CUC-IFB-15-010

WATERLINE REPAIRS FOR LEAK DETECTION

ADDENDUM NO. 1

Dated: February 06, 2015

3 GATE VALVE DETAIL
SCALE C-3
N.T.S.

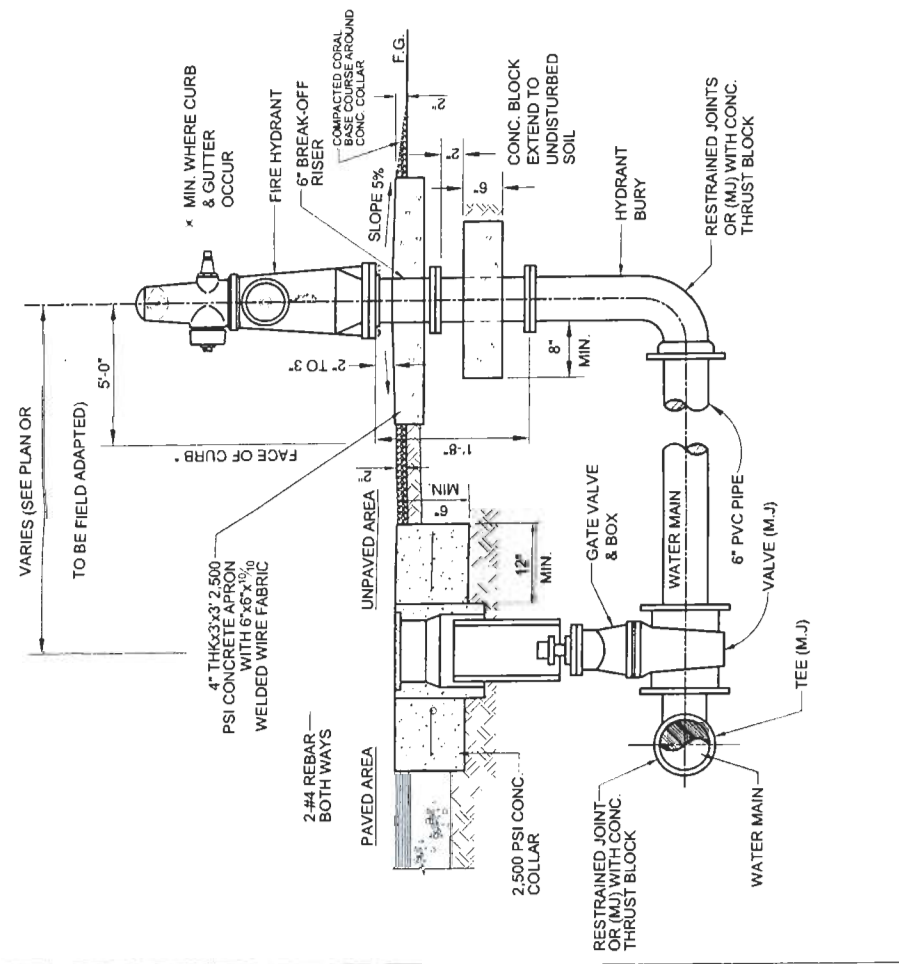
The attached sheet C-3 shall replace the detail for 3/C-3. The detail is a typical detail for a gate valve assembly.
